Memorandum

From: David Sellers; Facility Dynamics Engineering

Re: Variable Flow Refrigeration (VRF) Systems; the Field Perspective

Letter to Jim Wert
September 16, 2010

Figure 2 – Law Building Branch Controller Installation over Janitor’s Closet

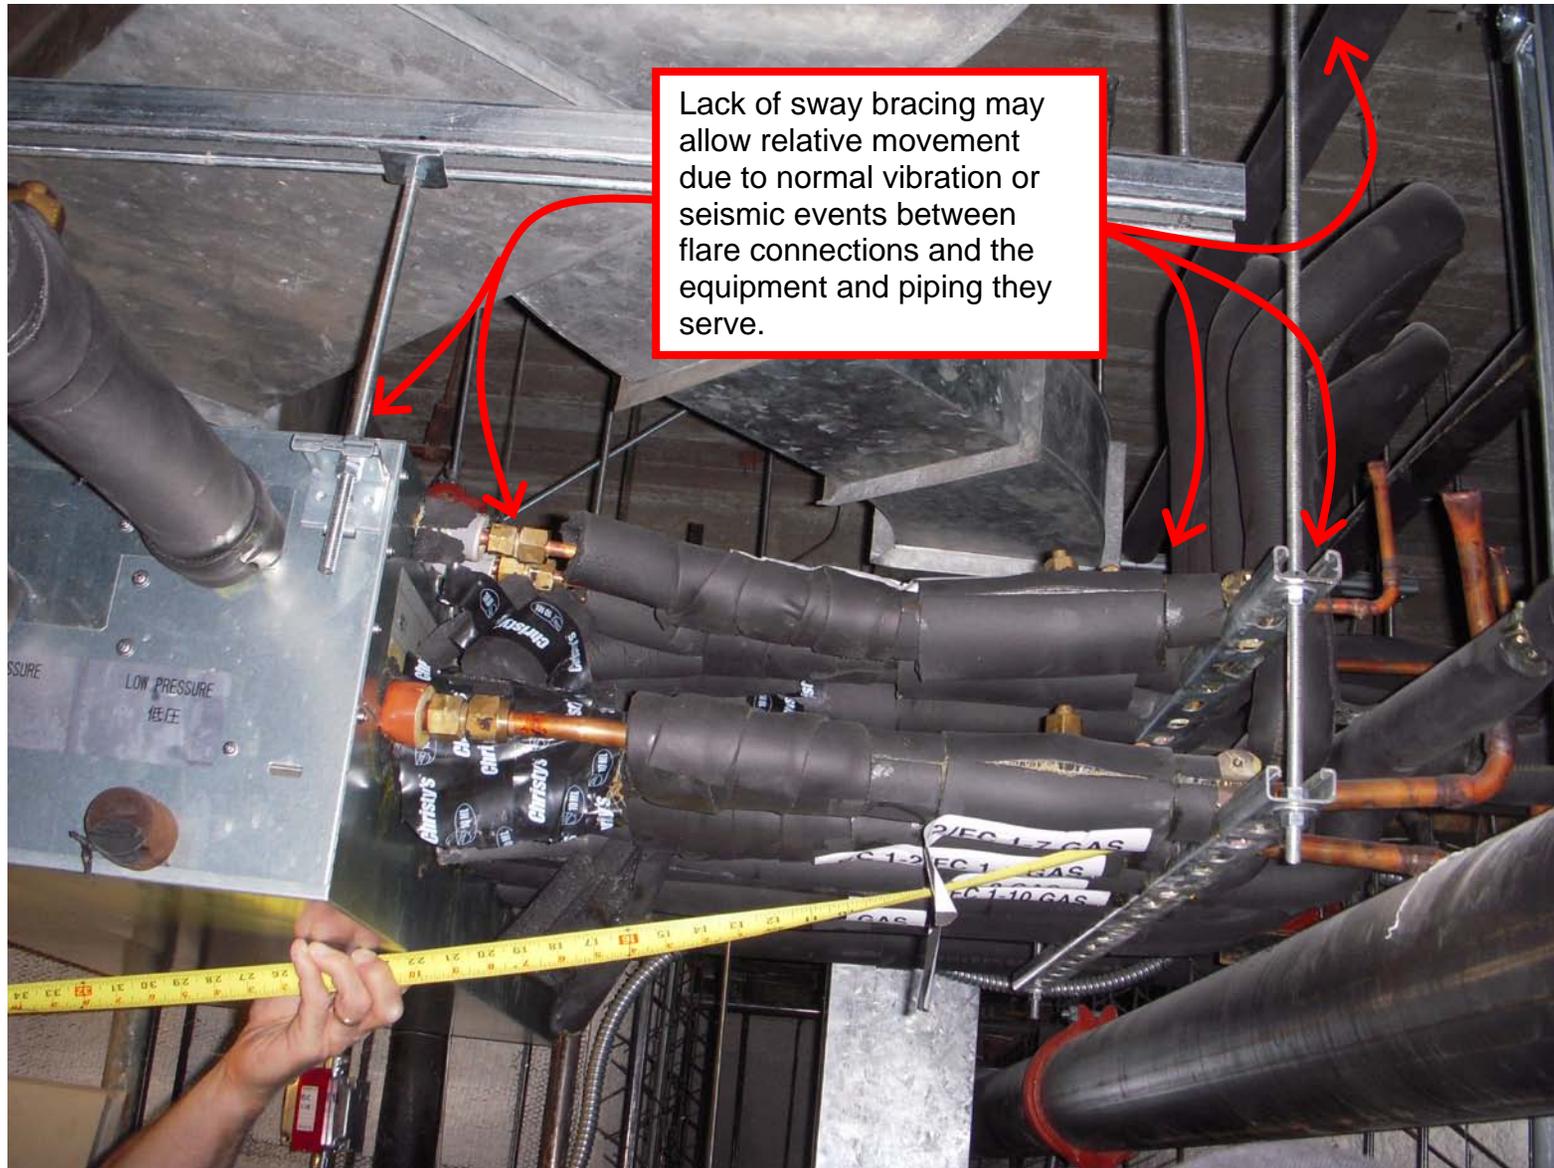
but details of the installation still allow relative motion between the pipe and equipment. The installation illustrated in Figure 2 is an example of this.

- Have a Mitsubishi Factory Technical Representative review the installations depicted in Figure 2 and Figure 3 to determine if additional bracing is required in their opinion, to comply with the intent of their requirements to prevent loads from being applied to the flare connections. If their conclusion is that additional bracing is required then this should be rectified by the contractors as part of the contractual requirement for complying with the manufacturers recommendations. If Mitsubishi thinks the installations are adequate, consider having the contractors provide additional bracing as an extra if the units will not be braced to deal with seismic concerns.

Figure 3 – Law Building Classroom Branch Controller Installation

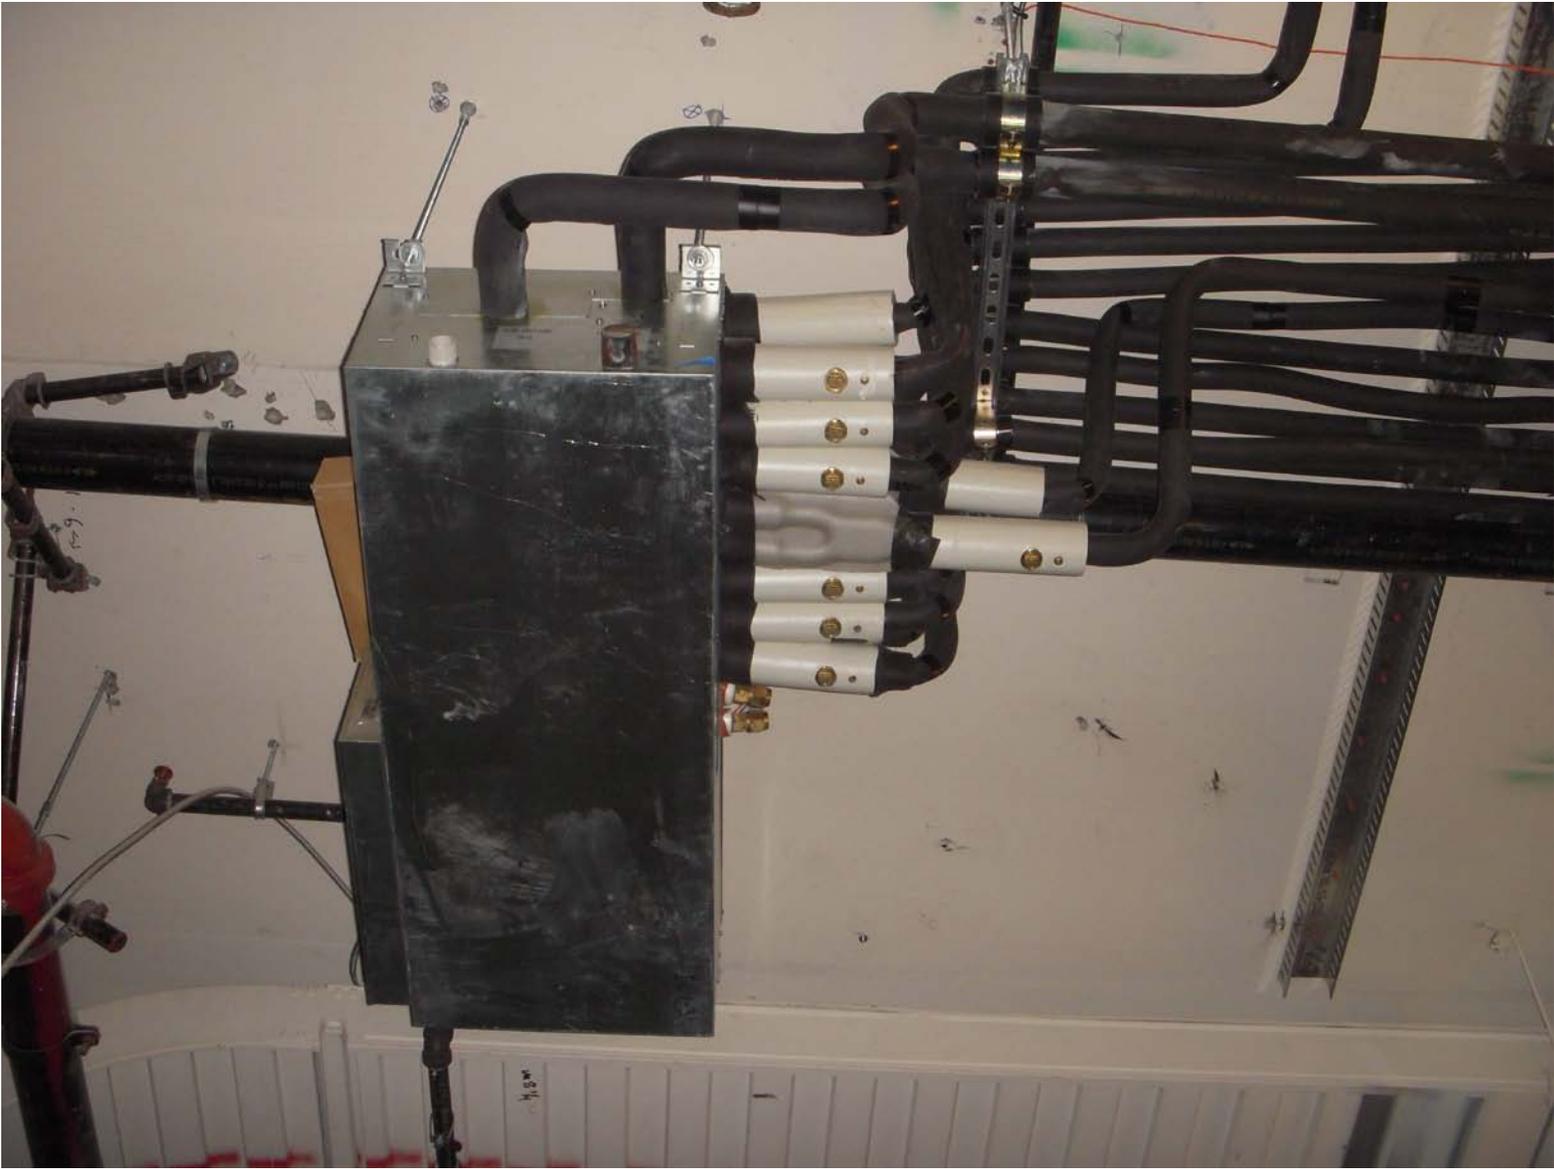
The obvious issue is that there is at least one instance so far where lines are not supported with-in 20 inches of the line, as can be seen in Figure 3 where the lines associated with the twinning kit connect to the branch controller. This is a clear deviation from the Mitsubishi requirement and should be corrected.

If such motion occurs, the angles between the piping and point of connection to the branch controller tend to change, which will place stress on the joints and could potentially cause a leak. Thus, the installation does not seem to comply with the stated intent of not placing a strain on the connections.

Seismic restraints would likely solve the problem as they would eliminate sway, especially if they were rigid vs. cable restraints. But for some situations like the one illustrated in Figure 3 and possibly, the one illustrated in Figure 2, the dimensions from the unit to the ceiling may be such that a seismic brace is technically not required. This means that it may be necessary to add sway braces to the branch controllers and pipe supports simply to ensure the intent of the Mitsubishi installation instructions are met and not rely on the seismic code requirements to address the issue.

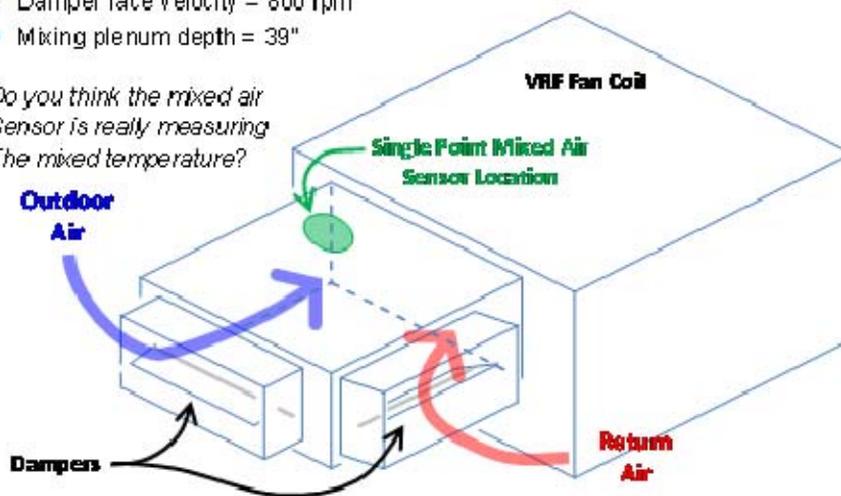
- From your presentation it appears you favor having the OSA sensor (enthalpy or temperature) remote upstream from the mixing box for optimum control.

[David Sellers] Not necessarily. The sensor I worry about the most is the sensor that controls the economizer; i.e. the sensor measuring mixed air temperature. My point is that (I know this from experience and measuring it) the temperature and velocity profile in a mixed air plenum, even a small one, can be quite stratified, and also quite dependent upon damper position, especially if the point you are looking at is immediately downstream of the damper location, meaning no time for mixing to occur. What that means in the context of the example in the slide below is:

- *The air temperature at the sensor location I show (the green circle) when the economizer is in some modulated state, is likely closer to the OA temperature than not and the temperature on the side of the plenum near the return damper is likely closer to that.*
- *The shape of the temperature profile will vary with damper position. At high return air flow, the return temperature will be reflected further across the plenum than at low return air flows and vice versa.*

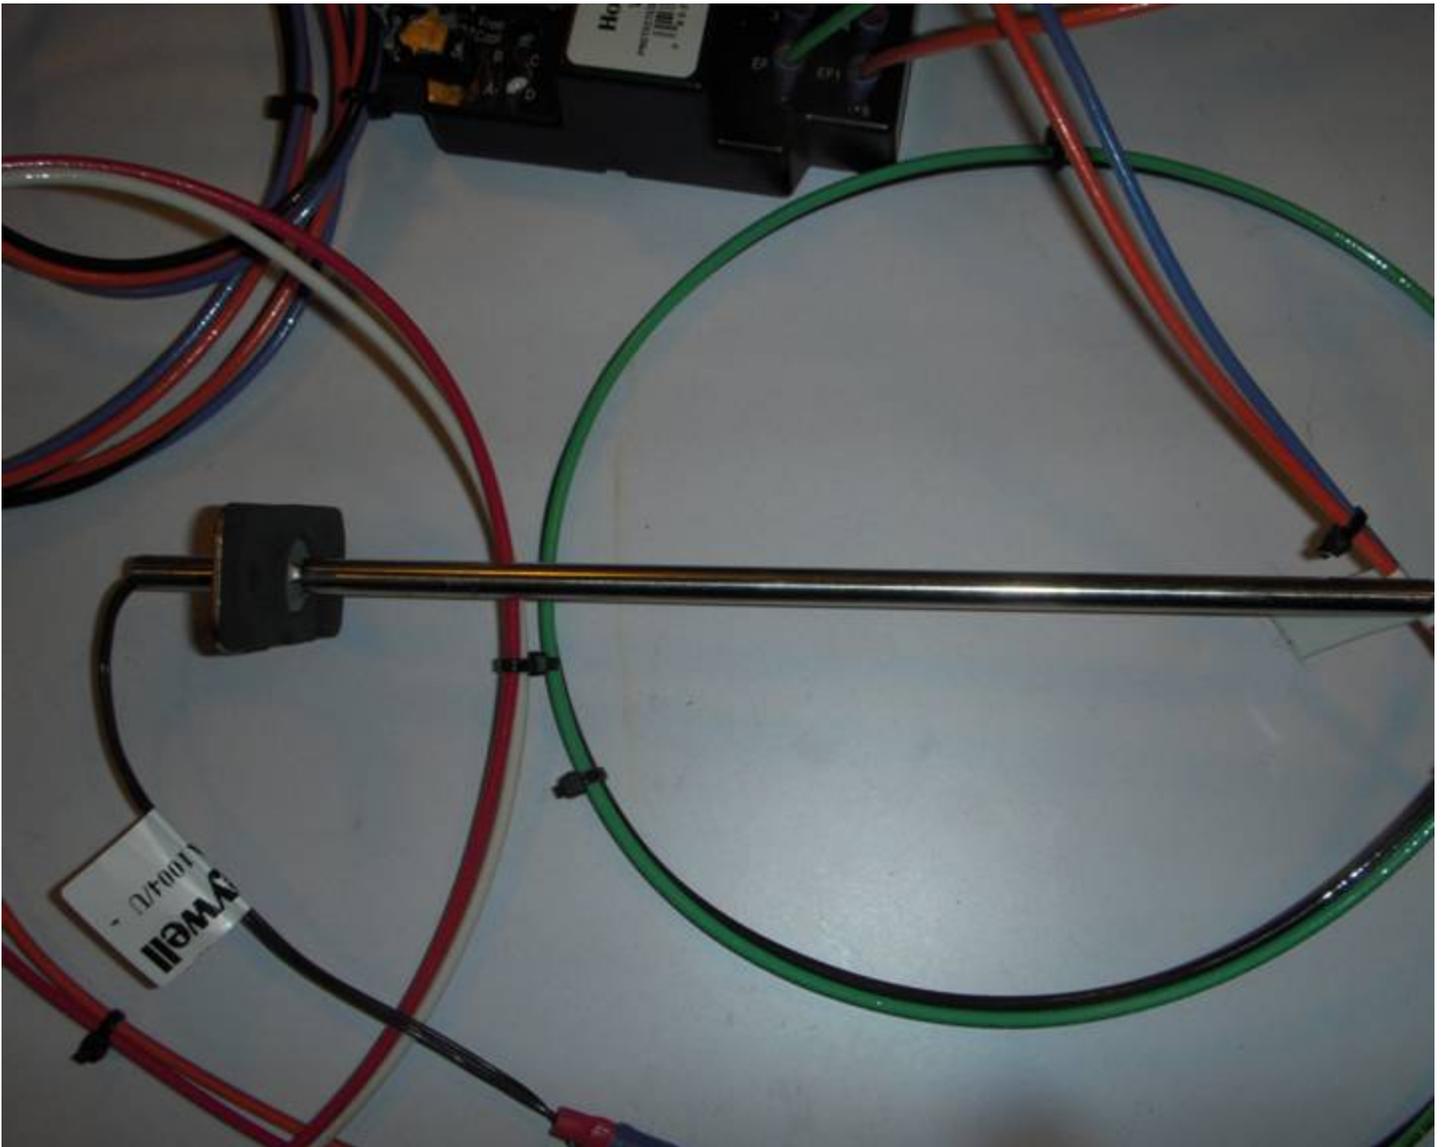
improved mount (bolt it to a plate) helps since at least the sensor is now more likely to see air flow.

But one still has to wonder how responsive the sensor will be and how good of a job it will do with the little louvers vs. a sensor directly exposed to the air stream. Probably better than the "clicks-on" which is the lowest cost approach so guess which one you will get on a low bid job or a "replace that as cheap as possible" maintenance order. But the "clicks-on" (and the dry bulb sensor Honeywell makes as an option) are likely more persistent than the enthalpy sensor because of the issues associated with measuring humidity, at least in my experience (see attached NBCIP reports, which document what anyone out in the field knew from experience) (we probably would have named the same names).

In this case, the OA duct is actually a duct from the discharge section of an economizer equipped AHU vs. a duct to a louver on an exterior wall some place (another discussion point, that I will reserve for our conversation unless you want me to elaborate before then; I would not be surprised if it happens a lot). What that means is that the OA duct is positive, not negative
